Our Ref: PM/5291

RE: NURSTEAD HALL, NURSTEAD LANE, LONGFIELD HILL

The purpose of the visit was to inspect cracking over the boiler room external door opening as well as various cracks around the exterior of the property. We comment on each elevation as follows;

Plate 1 – Opening up to West Elevation to Corner with South Elevation

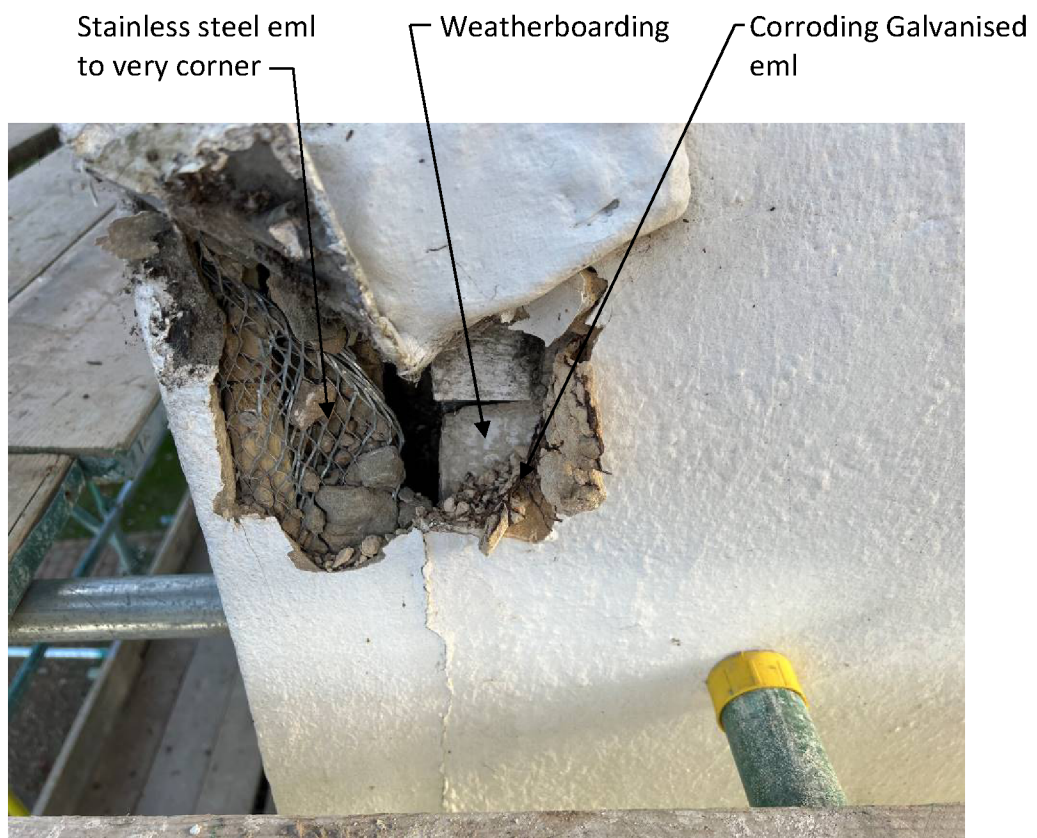
A vertical hairline crack is evident to the corner with the north elevation as well as hairline cracks elsewhere. A small inspection hole was formed which revealed timber weatherboarding directly beneath the external render finish (see plate 1 at the rear of this report). The render finish incorporated eml, which was generally found to be corroding except for the very corners where stainless steel was used. The weatherboarding was showing signs of decay.

Rendering on timber weatherboarding is extremely poor construction and will lead to numerous future problems including cracking, which is clearly evident in this case. We are therefore of the opinion that the render and weatherboarding should be removed and replaced with either new weatherboarding or re-rendered on a suitable render board.

Once the finishes are removed, an inspection should be made of the main oak framework behind to determine its condition and reinforced/strengthened as necessary.
